**Bulletin**

MODEL BENTLEY MARK VI

**MODIFICATION.****REAR BRAKE EQUALISER.**

FIG. 1.

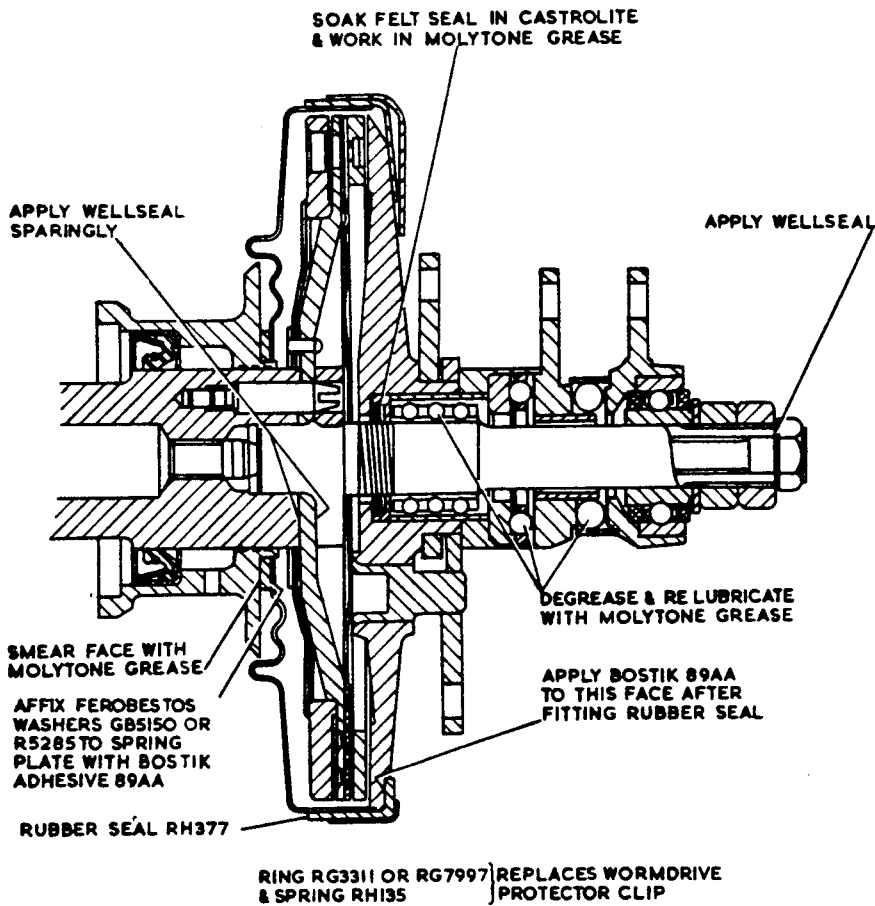
In order to ensure the fullest possible life, the servo motor sealing has been improved on production cars. Existing cars should be modified and brought to this standard, whenever a servo is dismantled.

1. Remove the water drain on the servo spring plate, this is simply done by unsweating.

Blank off the spring plate drain holes located in the rim, by filling with solder. This is best done by tinning the inside of the rim, resting the spring plate holes downwards on a sheet of asbestos, so that solder is prevented from running through and building up on the outside of the rim. The solder is then smoothed over and the spring plate repainted with a high quality air drying chassis black.
